2 Type of change

Modification of fixing hole.

4747 / 4748 Minibloc					0118.2181	
creation date	created by	release date	released by	notification no.	revision	page
2013-07-23	hotzar	2013-11-21	hotzar	25283		1 of 1

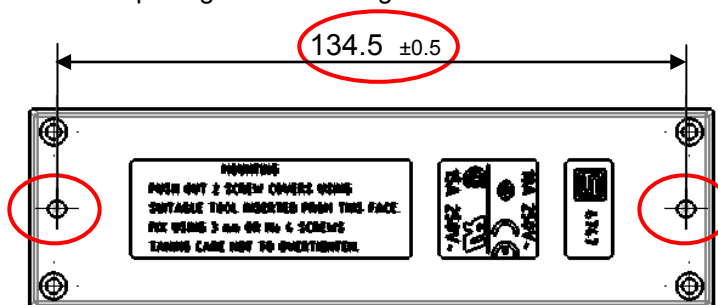
On bottom side, new shape of fixing hole for more hole spacing.

Old: circular fixing holes

New: elongated fixing holes

New spacing between fixing holes 134mm – 135mm

With the elongated shape of fixing holes, tolerance of hole spacing, 134mm to 135mm, can be met.

Form: New elongated fixing holes
Fit: Hole spacing 134mm to 135mm
Function: N/A
Production Site: N/A
Product Label: N/A
